PRODUCT CHANGE NOTIFICATION

Date: April 20, 2016
PCN: PCN LEDIL 117

Subject: PCN 117- Change of positioning pin locations in STRADA-2X2-T1 lens

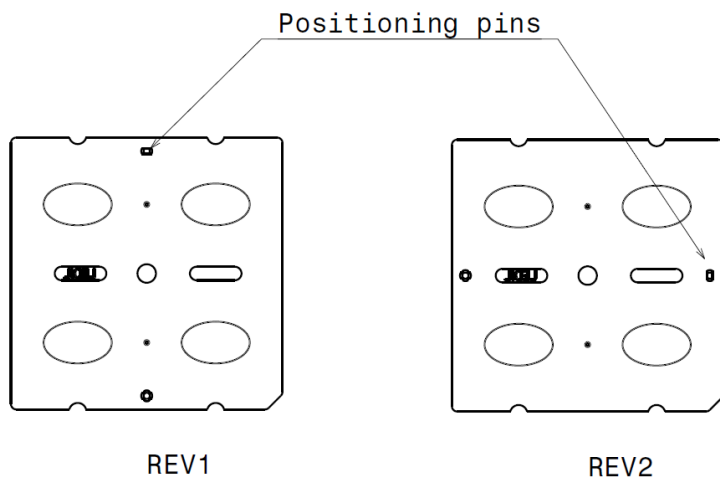
Description: C15135_STRADA-2X2-T1 street lighting lens is providing an asymmetrical light distribution that was not conforming to the product family because of 90 deg different beam direction compared to other similar products within STRADA-2X2 product family. Therefore LEDiL has changed two positioning pin locations to ensure better inter-product compatibility. The change will affect the lens to be assembled 90 deg differently on the PCB than before.

Changes: The two positioning pins of C15135_STRADA-2X2-T1 change rotation to
